Access Compliance Report

Public Rights-of-Way

Intersection ID: 44110	Main Street: GLENLUCE_AV	Cross Street: STAFFORDSHIRE_LN	Location:	E
ADA ID: 12EEBBFAE5B3	Ramp Type: Perp	Initial Pass/Fail: Fail	Overall Compliance: No	Severity Score: 12.5
Codes/Mitigation Info/Possible Solution		Field Measurements/Component Compliance

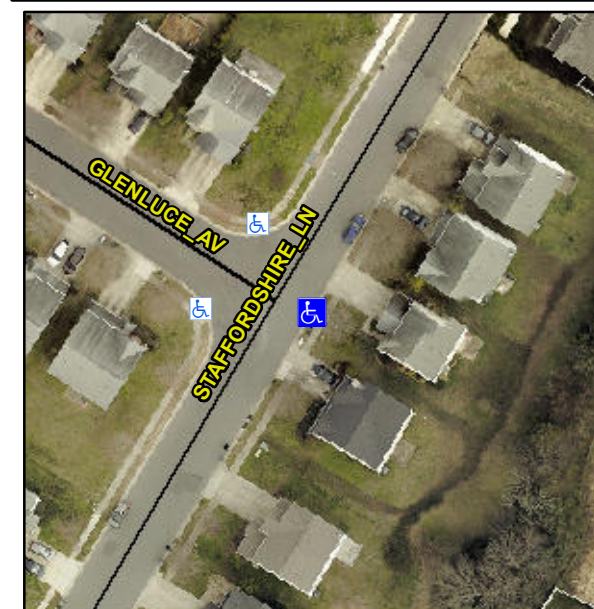
Not Found, R304.2.2

Compliance	Description	Data	Compliance	Description	Data
N/A	Ramp Length (in)	49.5	No	Ramp Slope (%)	10.2
Yes	Ramp Width (in)	48.0	Yes	Ramp XSlope (%)	1.2
N/A	Flare Type LT	N/A	N/A	Flare Type RT	N/A
N/A	Flare Slope LT (%)	N/A	N/A	Flare Slope RT (%)	N/A
N/A	Flare Traversable LT?	N/A	N/A	Flare Traversable RT?	N/A
N/A	Landing Length (in)	N/A	N/A	DWS Provided?	N/A
N/A	Landing Width (in)	N/A	N/A	DWS Contrast?	N/A
N/A	Landing Slope (%)	N/A	N/A	DWS Length (in)	N/A
N/A	Landing X Slope (%)	N/A	N/A	DWS Full Width?	N/A
N/A	Landing Curb? (Y/N)	N/A	N/A	DWS Offset (in)	N/A
N/A	Shared Landing?	N/A			
N/A	Gutter Ponding?	N/A	N/A	Gutter Slope (%)	N/A
N/A	Gutter Lip Ht (in)	N/A	N/A	Gutter X Slope (%)	N/A
N/A	Painted X Walk1?	No	N/A	Painted X Walk2?	N/A
	X Walk 1 Direction	To W		X Walk 2 Direction	N/A
N/A	X Walk 1 Width (in)	N/A	N/A	X Walk 2 Width (in)	N/A
	X Walk 1 Slope (%)	1.9		X Walk 2 Slope (%)	N/A
	X Walk 1 X Slope (%)	2.4		X Walk 2 X Slope (%)	N/A

Remove & Replace Entire Ramp.
